# TRAILS AT ASPEN RIDGE FILING NO. 5

## ROADWAY IMPROVEMENT PLANS

OCTOBER 2021

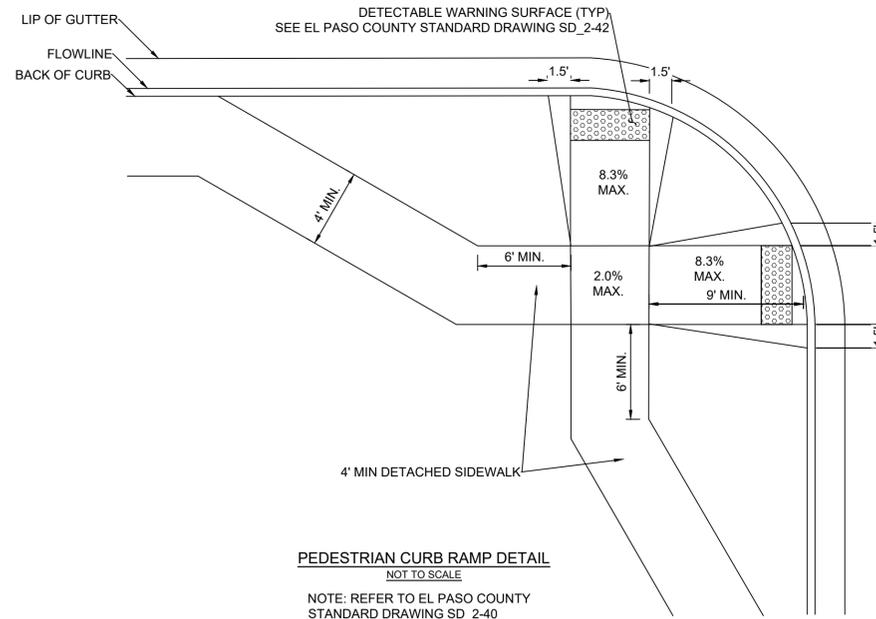
Include design & posted speed for street section

**EPC OPTIONAL TYPE C (ROLLOVER)**

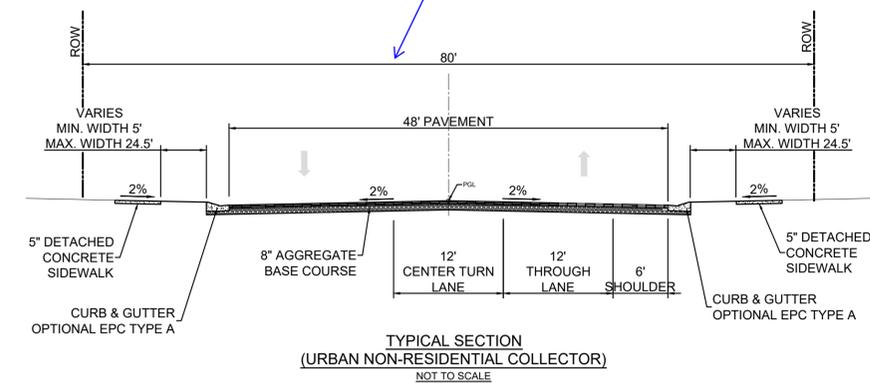
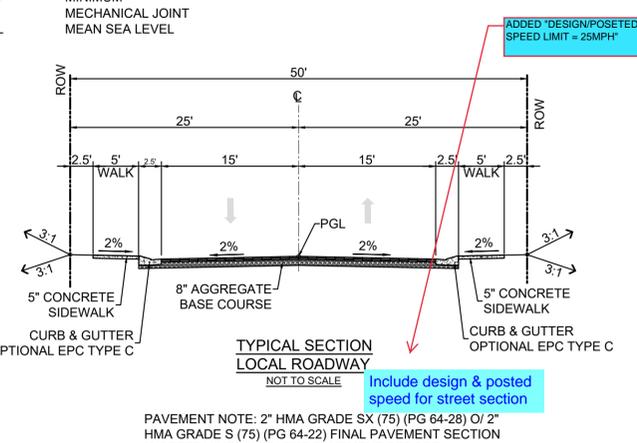
Is this section used in this plan set?

<b>TRAILS AT ASPEN RIDGE</b>			
FILING NO. 5 ROADWAY IMPROVEMENT PLANS			
<b>ROADWAY PLAN &amp; PROFILE</b>			
DESIGNED BY: CRD	SCALE: 1" = 40'	DATE ISSUED: OCTOBER 2021	DRAWING No. RD02
CHECKED BY: NMS	VERT. 1" = 5'	SHEET 6 OF 15

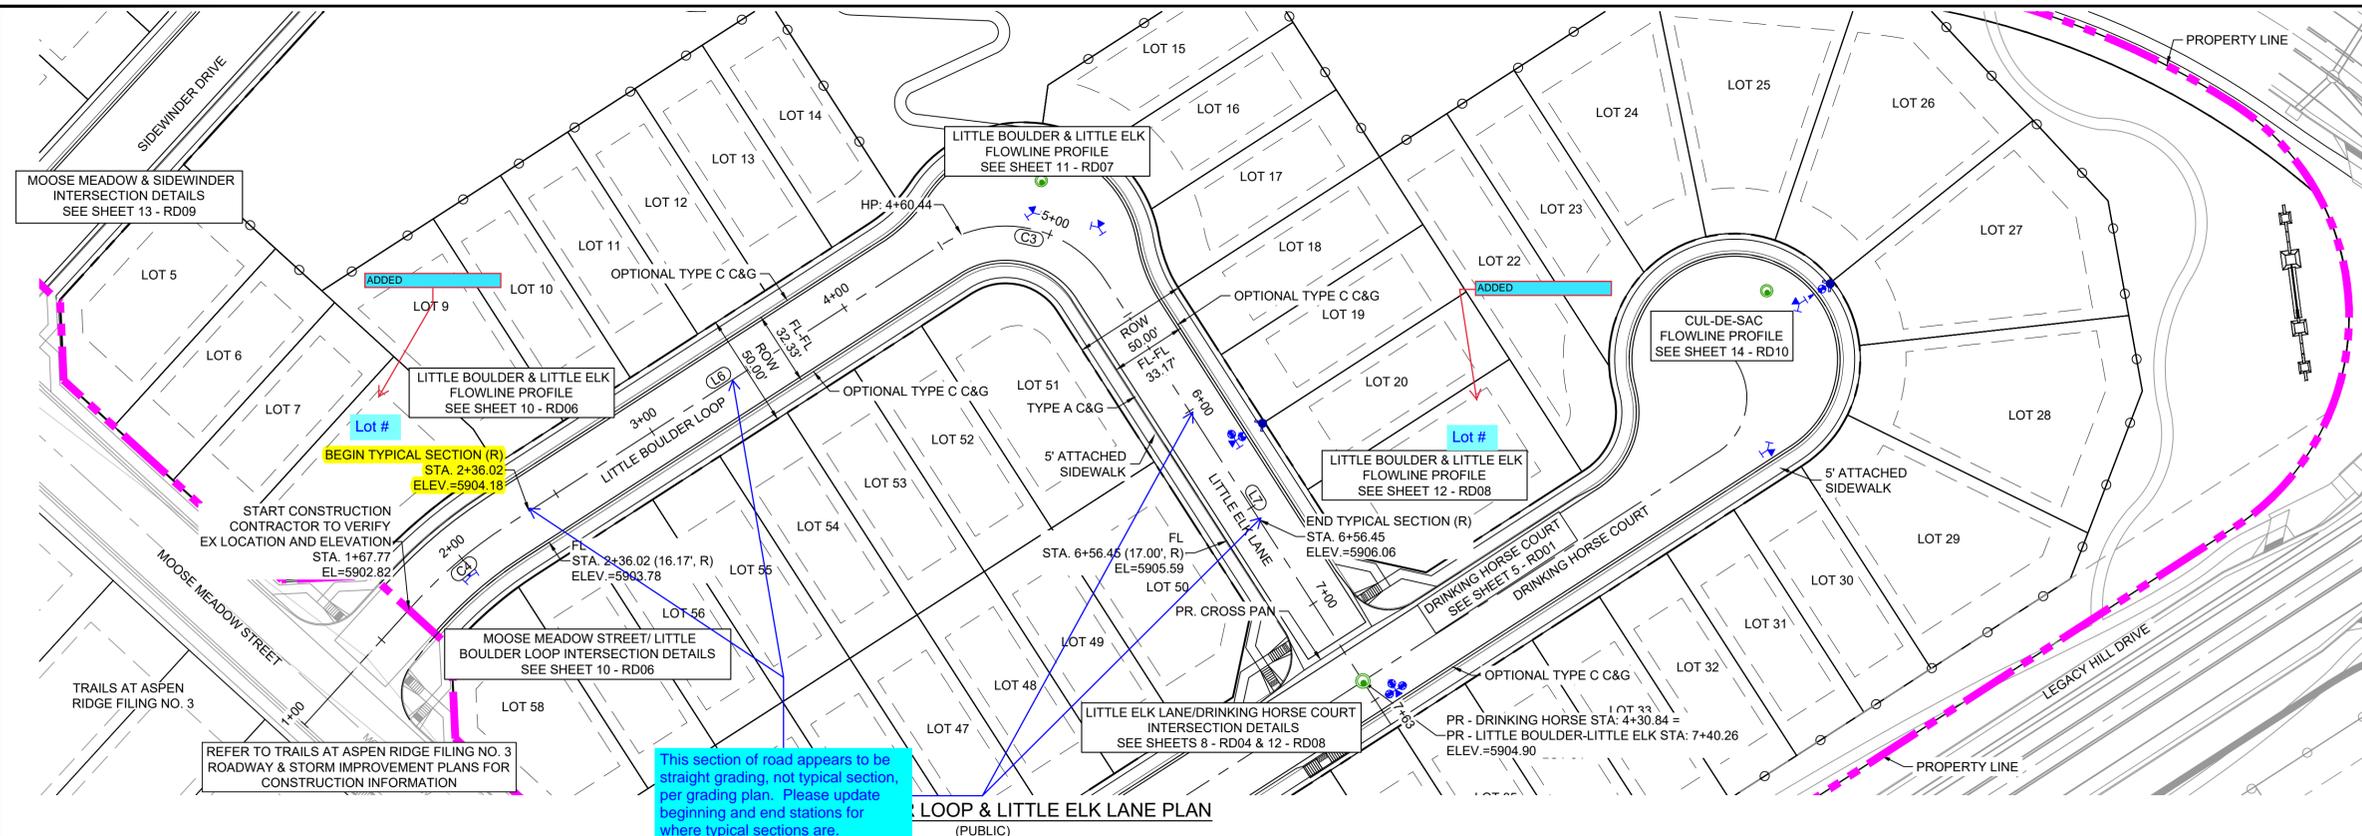
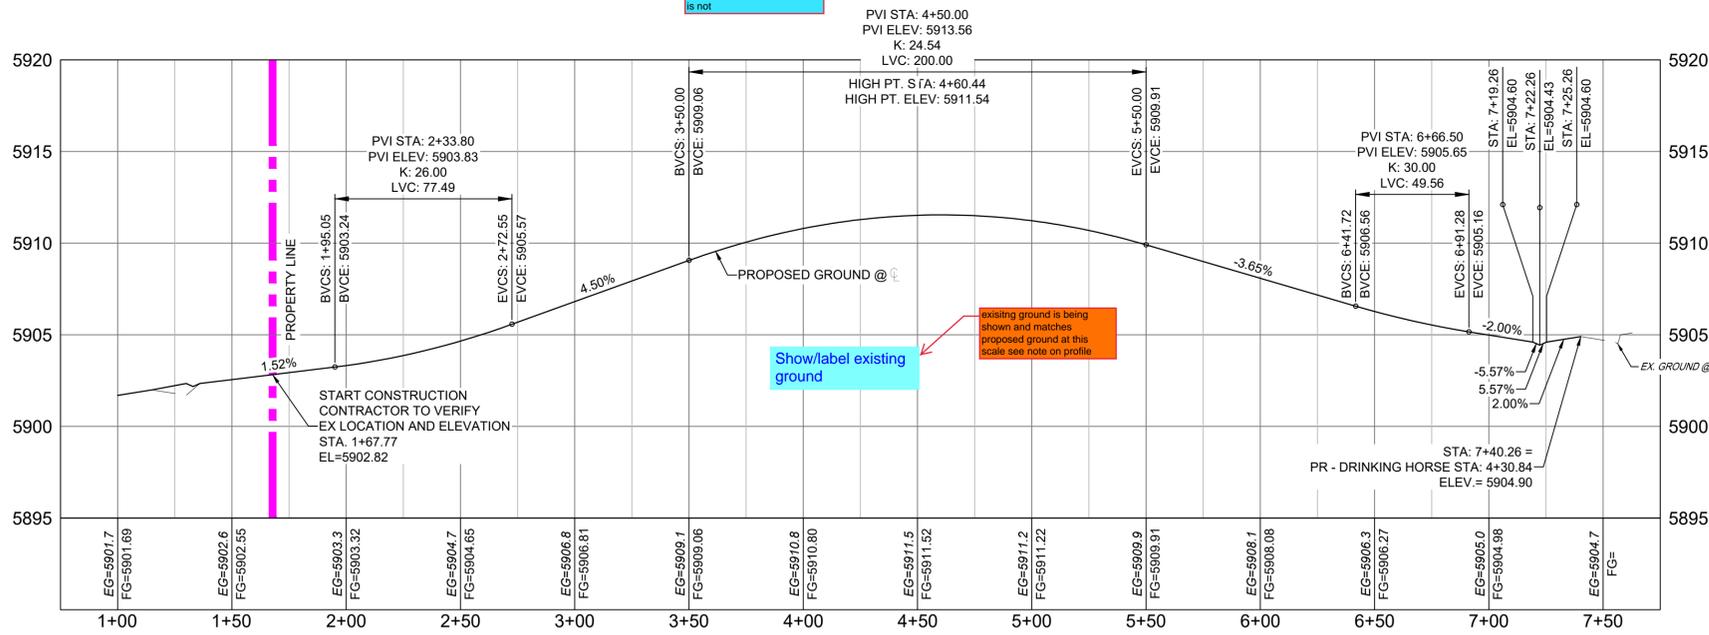
This section of road appears to be straight grading, not typical section, per grading plan. Please update beginning and end stations for where typical sections are.

right side is in fact typical, left is not

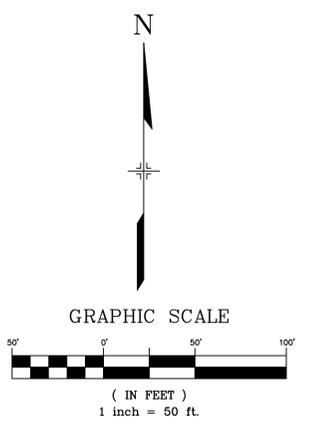
REMOVED  
remove sign
